Product Change Notification / SYST-23EQNR513

ERRATA - PIC18F27/47/57Q43 Family Silicon Errata and Data Sheet Clarifications Revision

PIC18F27/47/57Q43 Silicon Errata and Data Sheet Clarifications

1.7.1 UART TXDE Signal May go Low Before The STOP Bit Has Been Entirely Transmitted.

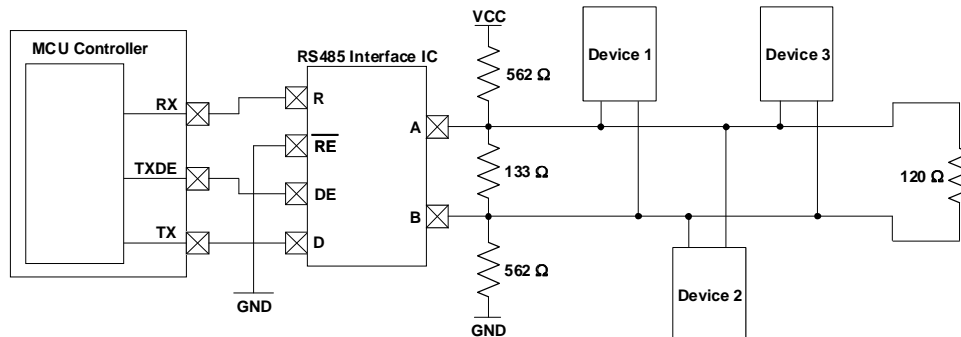
The UART Transmit Drive Enable (TXDE) signal could potentially transition into a low state before the UART STOP bit has been entirely transmitted due to the effects of parasitic capacitance on the TX line. In some applications, this could result in communication being prematurely terminated due to the TXDE bit going low before the STOP bit has had enough time to settle.

In order to ensure that the STOP bit settles into its final logic state before the TXDE signal transitions low, a biasing circuit can be implemented. A biasing circuit allows the TX line to either be driven high or low, rather than being left in a floating tri-state mode where prolonged rise or fall times could lead to communication being disrupted. This bias circuit should only be implemented on one end of the serial bus, and a termination resistor should be used on the other end. The figure below show an example of a bias circuit that can be used to achieve this. Please note that the resistor values used in this circuit are recommendations, and that the actual resistor values required may vary based on the application.
